Office Action Summary	Application No. 10/579,343	Applicant(s) PRIOUL ET AL.	
	Examiner JEFFREY ALLEN	Art Unit 3781

DETAILED ACTION

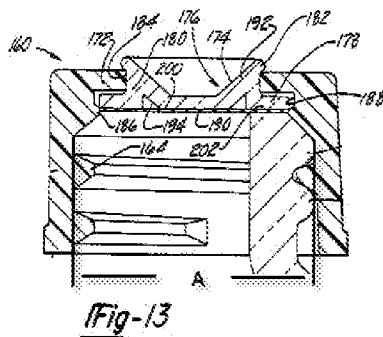
12. Regarding claim 4, the modified closure of Gach teaches the maximum radial dimension of the membrane being less than the outside diameter of the lip (lip is designated by A in drawing below labeled by examiner).
